Technical Service Bulletin

No. D67-19-4

Steering
Column Horn
Ground Clip

MODELS: 1967
Dart, Coronet,
Polara, Monaco
and Charger
Equipped With
non-Adjustable
Steering Wheel
Built Before
March 15, 1967

Figure 1

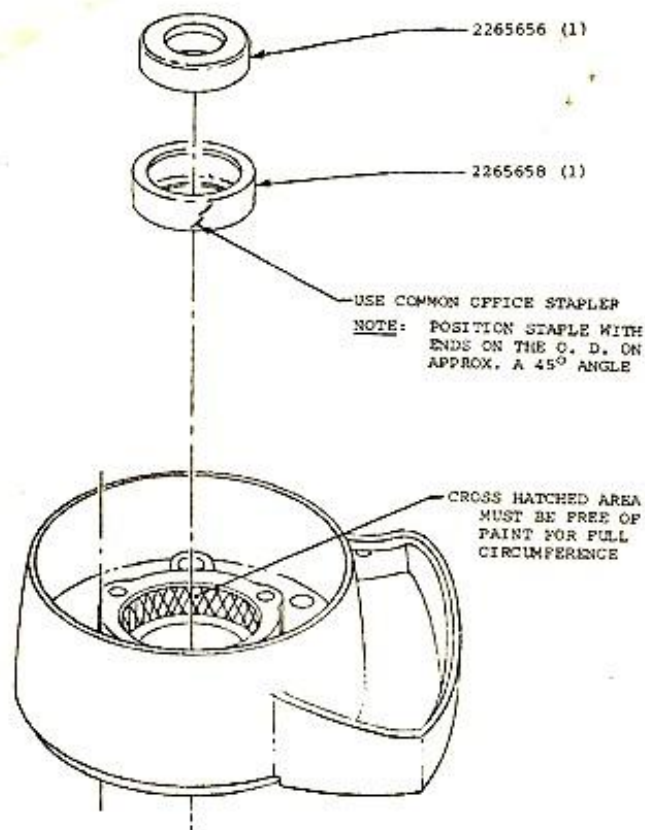
If you should encounter a condition of a scraping noise within the steering column on the subject models it may be caused by the steering shaft ground clip rubbing on the shift tube.

To correct a condition as described above remove and disassemble the steering column. Refer to Technical Service Manual for service procedures and remove and discard the horn ground clip. Refer to

Figure 1 and install one (1) staple in the upper steering column bearing insulator as shown in sketch. Following the re-assembly and installation of the steering column provide an alternate ground path by installing a wire as shown in Figure 2.
